ASSESSMENT REPORT
Invincible Colliery
Southern Extension Modification
(07_0127 MOD 5)

Assessment Report
Section 75W of the
Environmental Planning and Assessment Act 1979

November 2017

Figure 4: Nearby Pagodas and Geo-Diversity Features

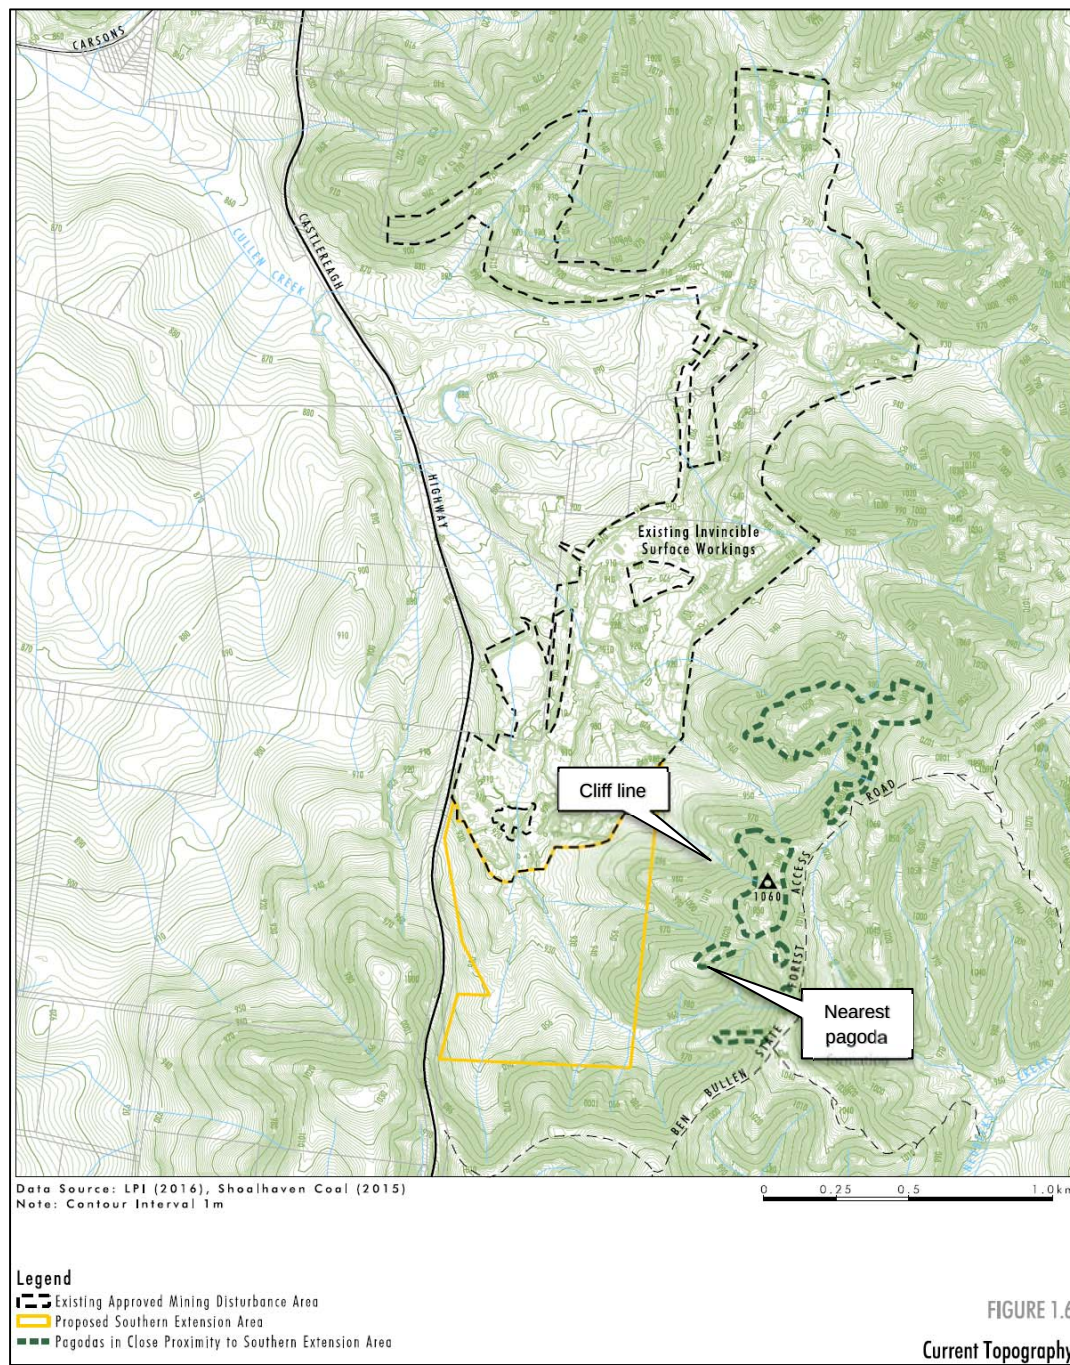
The proposed mine plan includes a buffer of around 210 m between open cut mining associated with the proposal and a pagoda formation to the east of the site, and a buffer of approximately 200 m to an isolated cliff line (see **Figure 4**).

Unlike previous proposals, the proposed modification does not include any highwall mining and, as a result, the proposal would not have any subsidence impacts on pagodas. Consequently, the only risk to the structural integrity of pagodas and the isolated cliff line located in proximity to the proposed Southern Extension Area, is associated with potential impacts from blasting.

The EA includes a detailed blasting assessment which considers the structural integrity of pagoda landforms and the isolated cliff line, and includes an analysis of damage criteria for sandstone, and other comparative features. In summary, the assessment concludes that blasting impacts could be mitigated by managing ground vibration to 50 mm/s for pagodas and 25 mm/s for the nearby cliff line. These targets would be achieved using an maximum instantaneous charge (MIC) of 175 kg.

While flyrock also has the potential to impact pagodas and geo-diverse features, Castlereagh Coal considers that any impacts could be managed through appropriate blast design and that flyrock could be controlled to approximately 50 m from blasting.

Figure 5: Castlereagh's Preferred Conceptual Final Landform (Option 1)

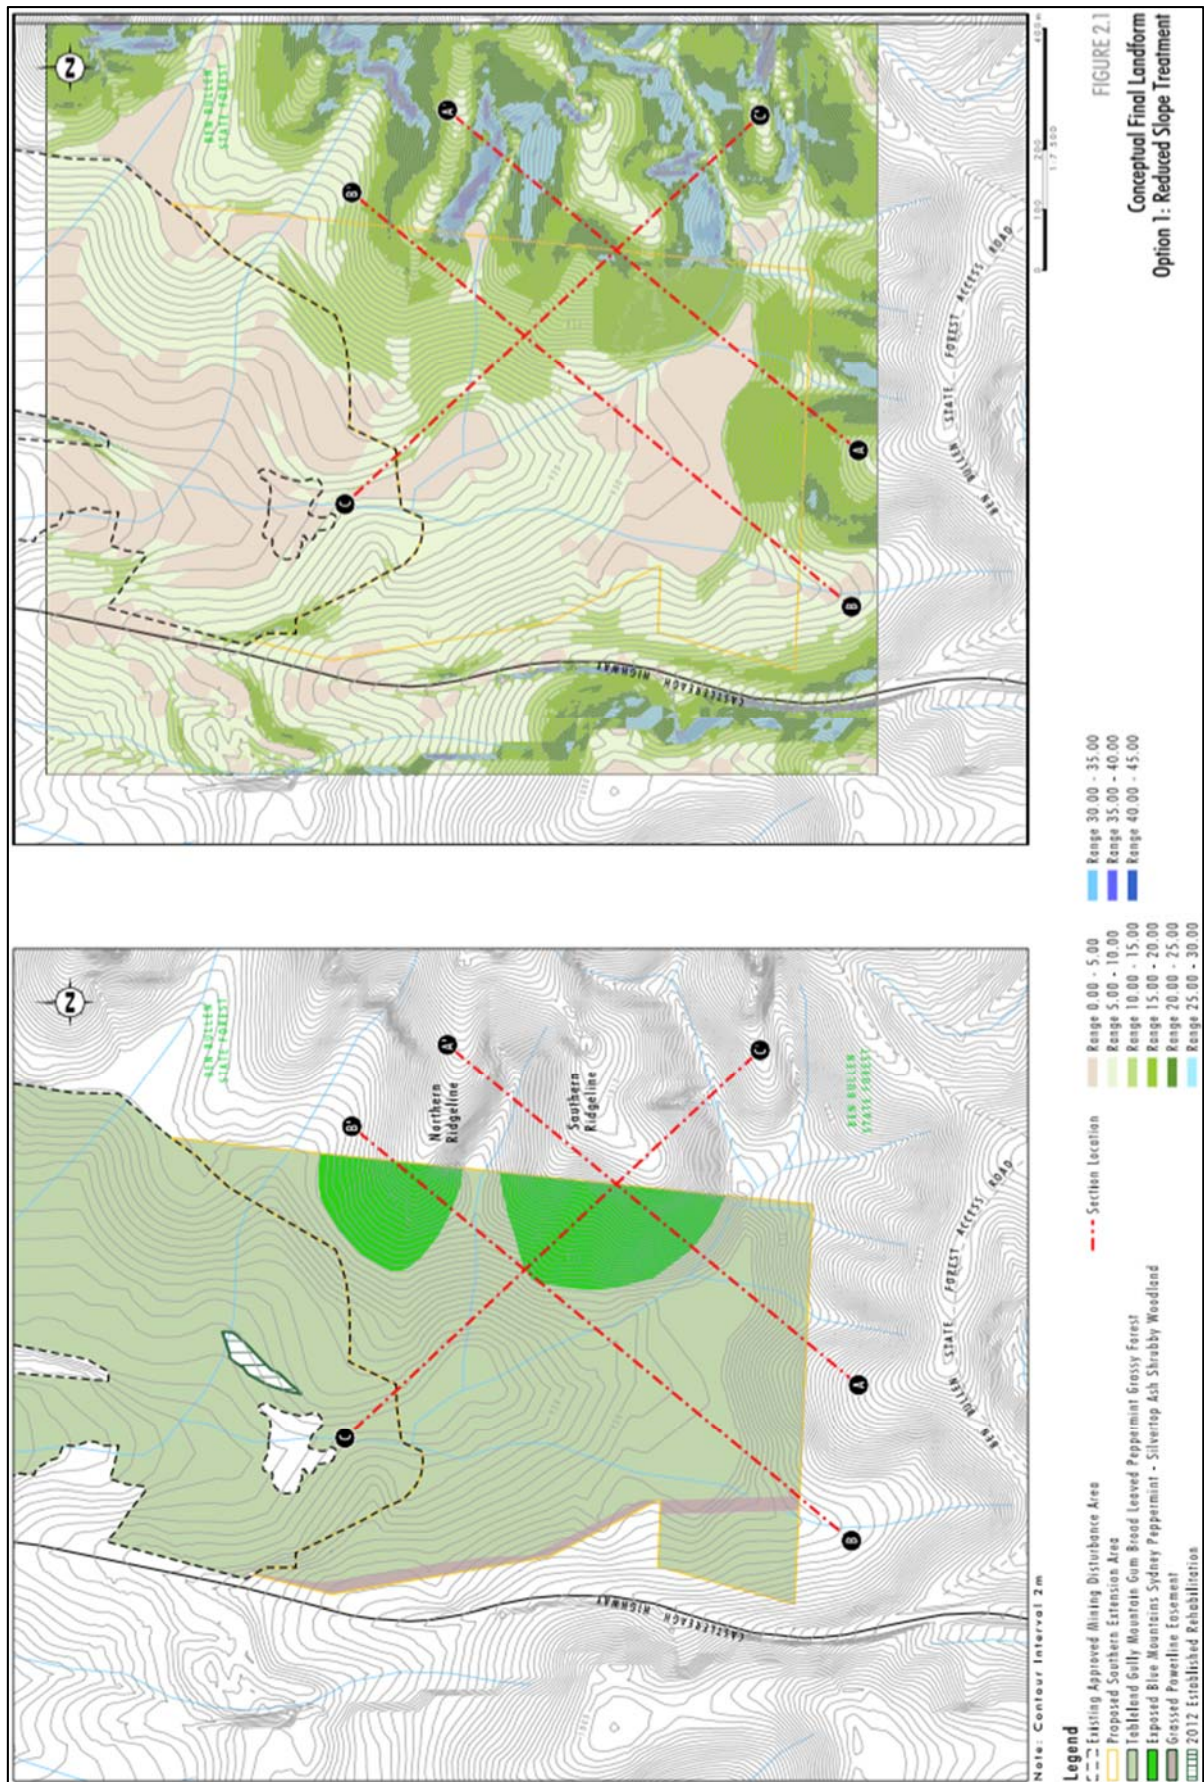
Castlereagh Coal's preferred rehabilitation option (Option 1) for the application is shown in **Figure 5**. This option seeks to reduce the gradient of slopes relative to the rehabilitation strategy presented in the EA (through the use of surplus overburden) and would maximise the benefits of the project (including resource recovery) relative to the alternative rehabilitation options.

Castlereagh Coal has also mounted arguments that the rehabilitation proposed as part of the modification is substantially different to prior rehabilitation undertaken on the site (see **Appendix E**). In particular, that the final landform would result in much shallower slopes than the West Pit Area (which has slopes up to 30 degrees) and that the proposed rehabilitation would not be constrained by the same factors that delayed and limited rehabilitation in this area.

Figure 6: Alternate Final Landform Options

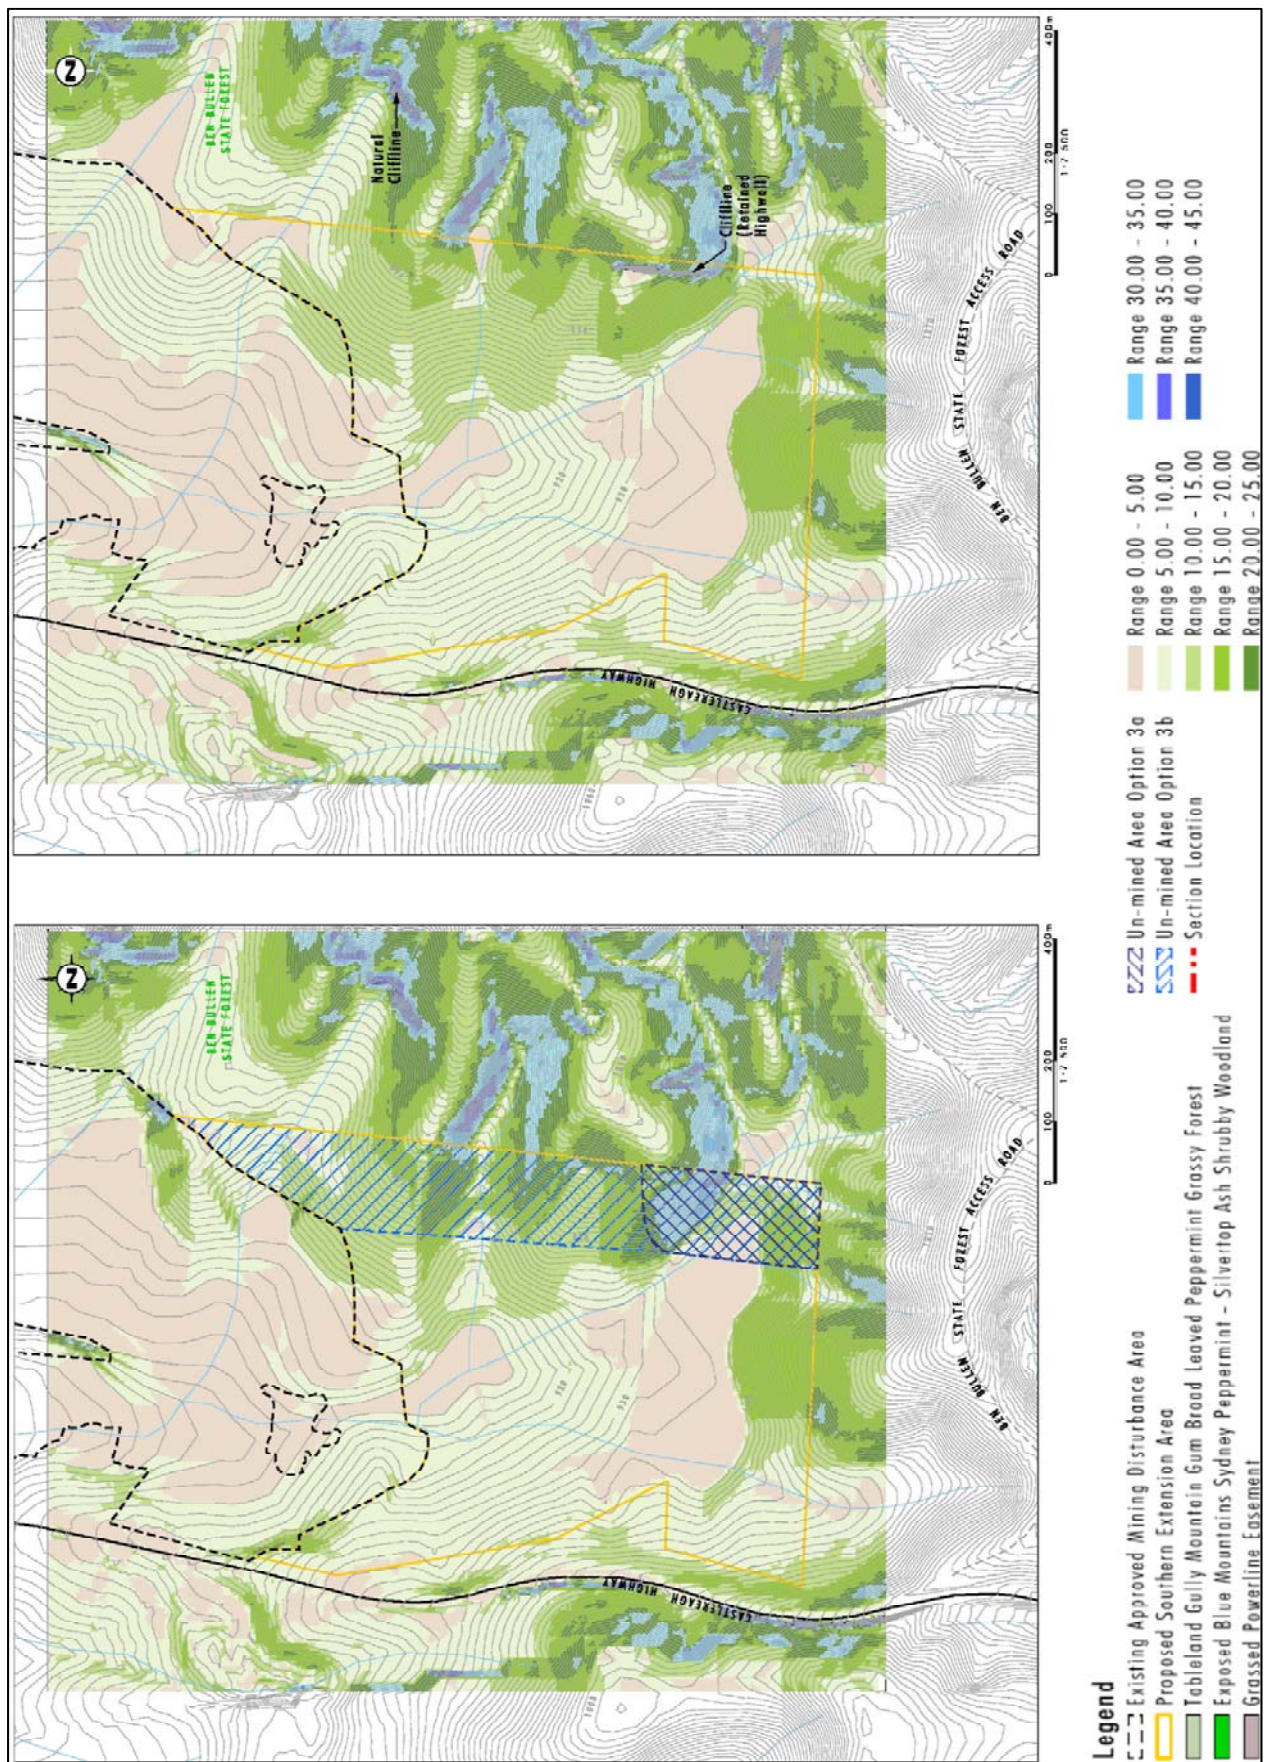
In June 2017, Castlereagh Coal provided a written response to these concerns, which included consideration of a number of options to minimise steep slopes as part of the final landform (see **Appendix E**). These are shown in **Figures 5 and 6** and include options to:

Consequently, the Department has recommended a condition restricting mining operations from being undertaken in the steep areas of the site that are located closer to pagoda formations and the isolated cliff line. The Department's recommendation is consistent with Option 3b provided by Castlereagh Coal in its option analysis for avoiding steep slopes. (see **Figure 6**).

Figure 7: Vegetation Communities

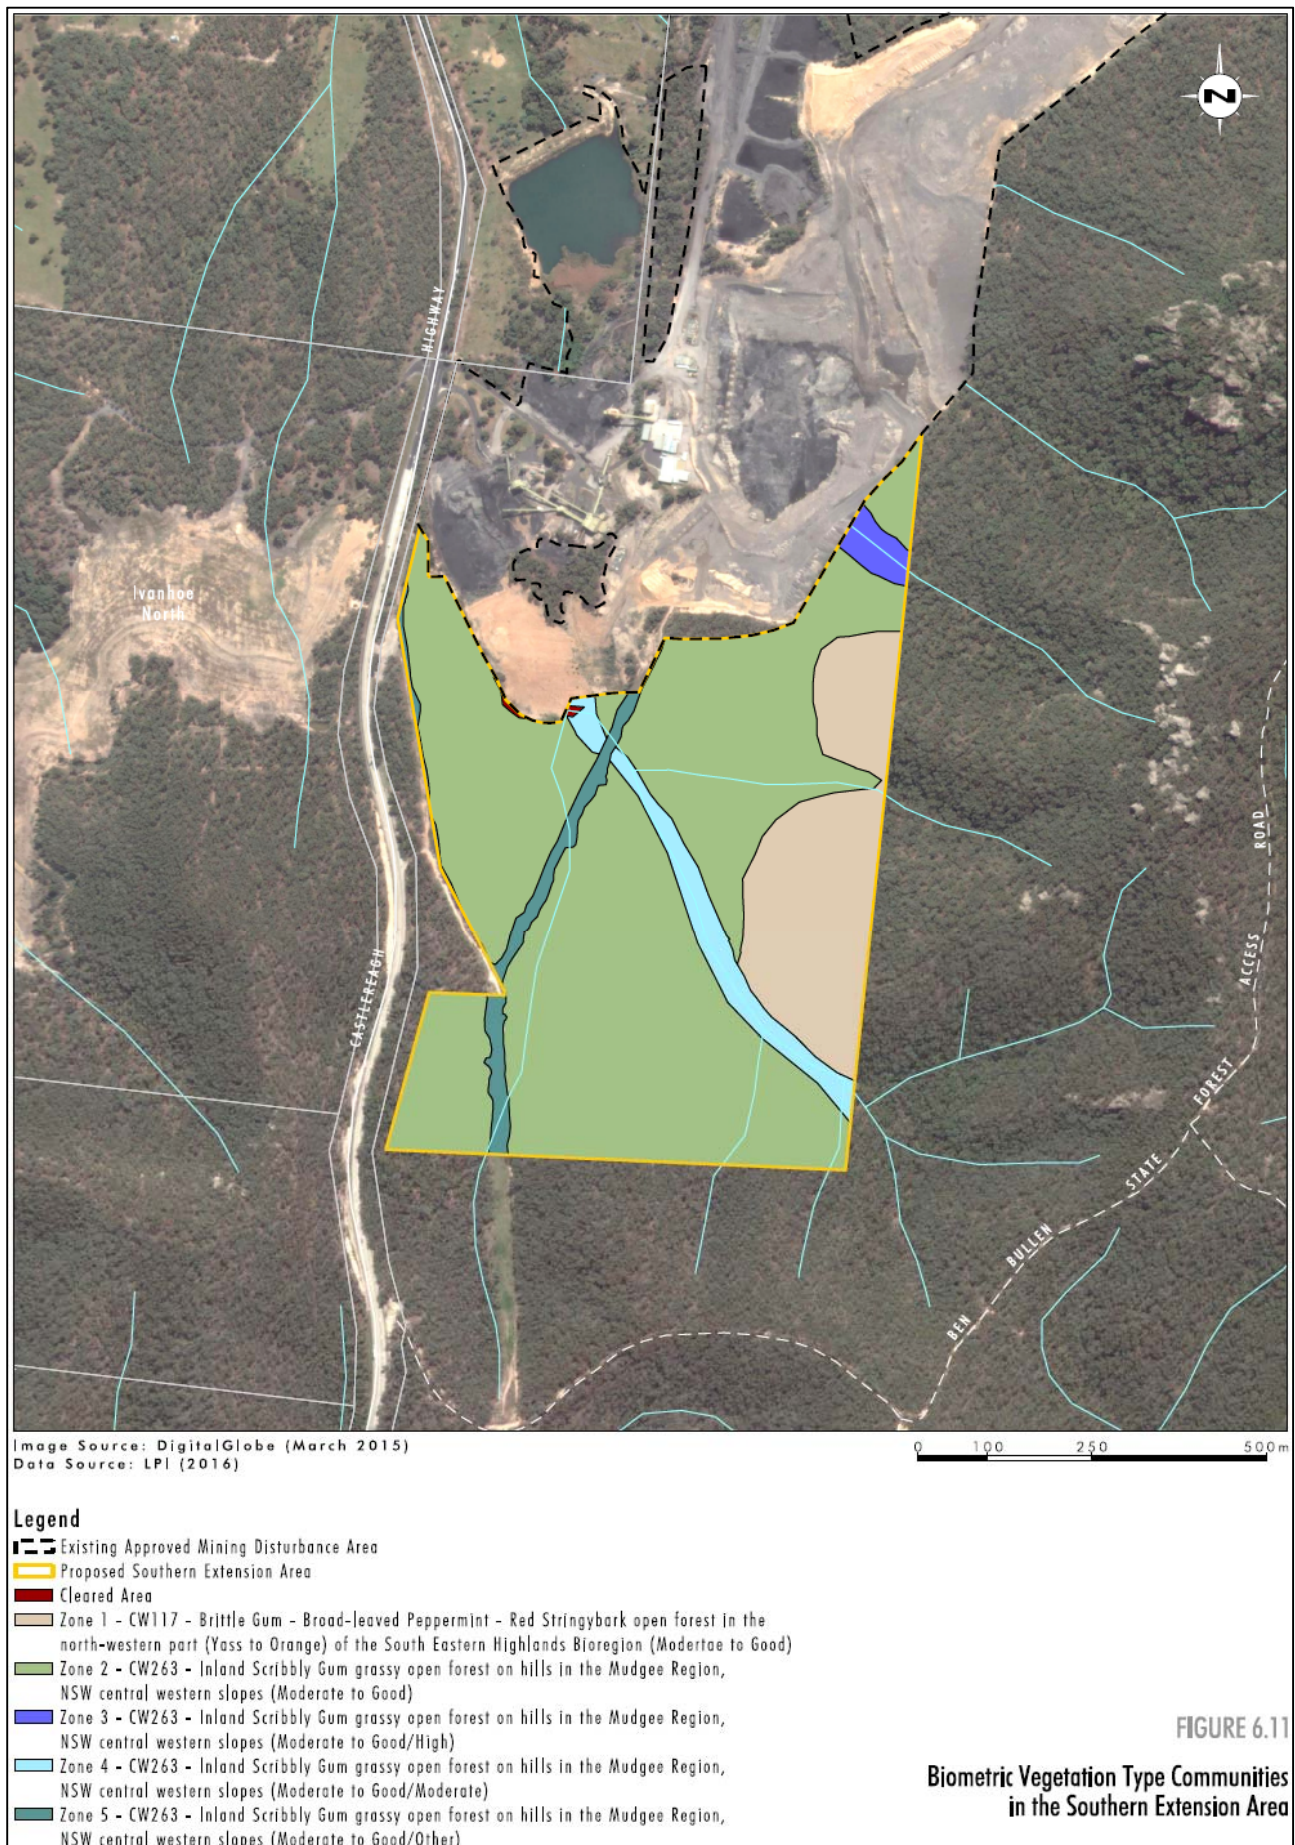
The BAR found that the proposal would result in the disturbance of approximately 50 ha of native vegetation within the Ben Bullen State Forest consisting of 2 biometric vegetation types (BVTs) (see **Table 3** and **Figure 7**).
